AMENDMENT OF SOLICITATION/MODIFICATION OF CONTRACT				1. CONTRACT ID CODE <div style="text-align: center;">J</div>		PAGE OF PAGES <div style="text-align: center;">1 2</div>

8. NAME AND ADDRESS OF CONTRACTOR (No., Street, County, State and Zip Code)				X		9A. AMENDMENT OF SOLICITATION NO. N00174-06-R-0061	
				X		9B. DATED (SEE ITEM 11) 30-Aug-2006	
						10A. MOD. OF CONTRACT/ORDER NO.	
						10B. DATED (SEE ITEM 13)	
CODE		FACILITY CODE

THE SOLICITATION N00174-06-R-0061 IS AMENDED AS FOLLOWS:

Chamber Dimensions 25'x25'x50'

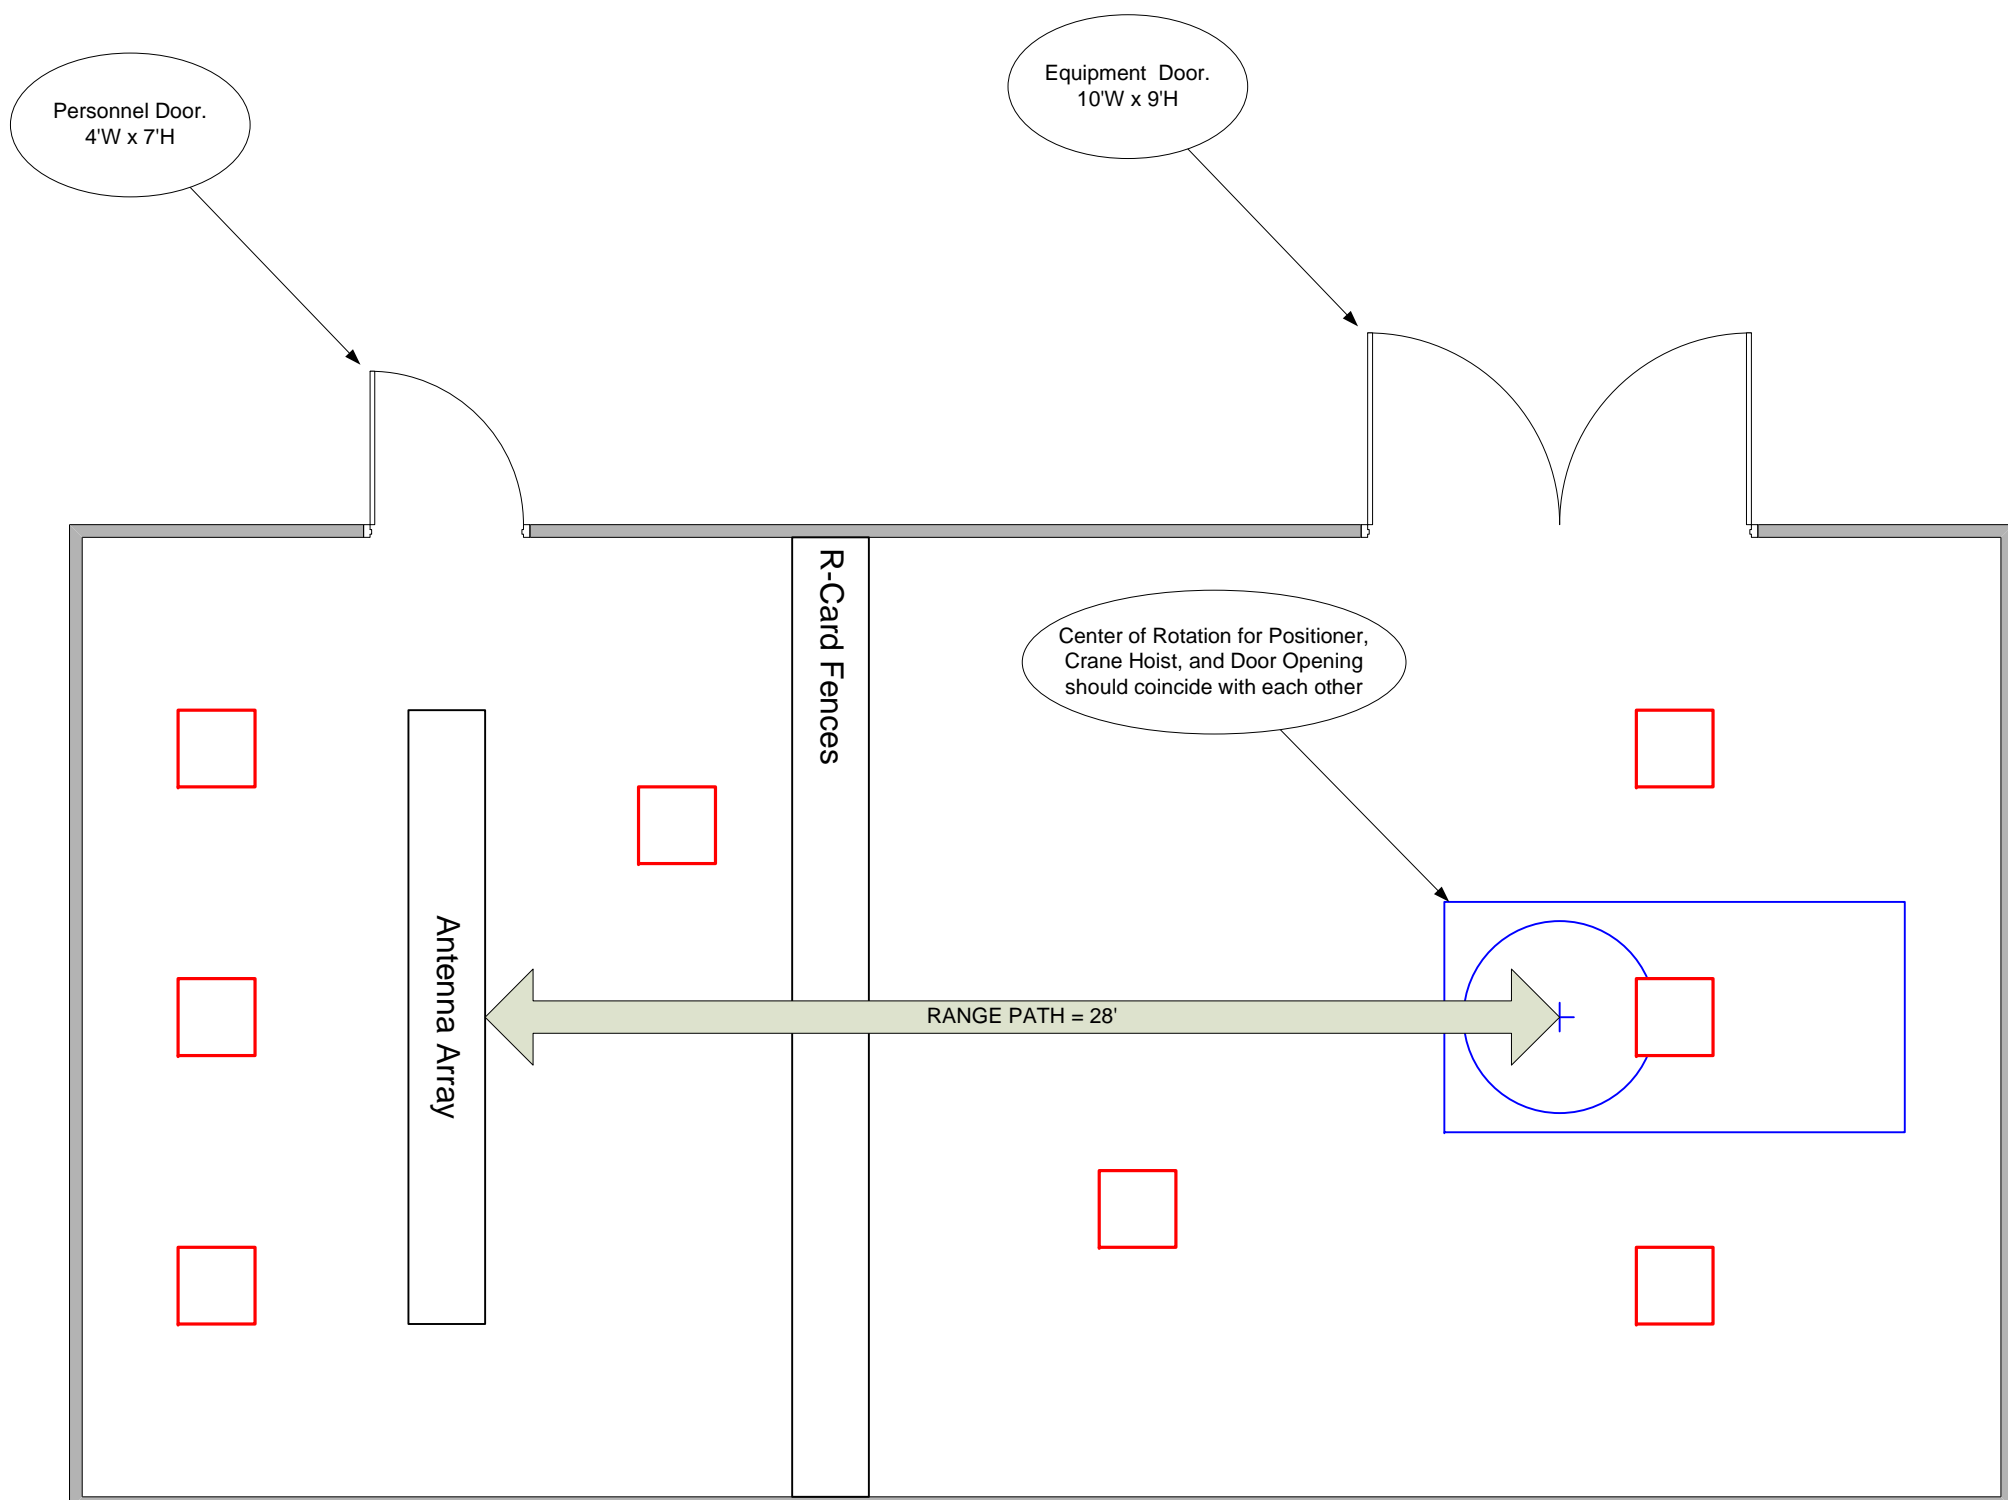
- 5) The Scope of Work calls for 2' X 2' surface mount fluorescent light fixtures mounted to the ceiling.**
 - Fluorescent lights create RF noise that can interfere with testing. This will be a concern when writing our performance guarantee. Will the Department accept metal halide lights instead?**Yes**

- Please clarify how the Department envisions these lights being mounted **SEE BELOW**, as there will already be absorber material mounted to the ceiling. Is Hi-Hat lighting desired? **Yes**

- 6) Does the Department have a conceptual drawing of the facility or can the Department provide a description of how they anticipate the shielding, hoist, absorber and door to operate within the chamber? **See Below****

- 7) Can the Department provide an electrical schematic or description, showing what services are required? **See Below****
- 8) Can the Department provide a list of approved Vendors? **No****

Light Fixtures are shown in the desired locations. However, locations shall take a lower priority to Structural and RF requirements.

Doors are also shown in their desired locations. However, locations shall take a lower priority to Structural and RF requirements.
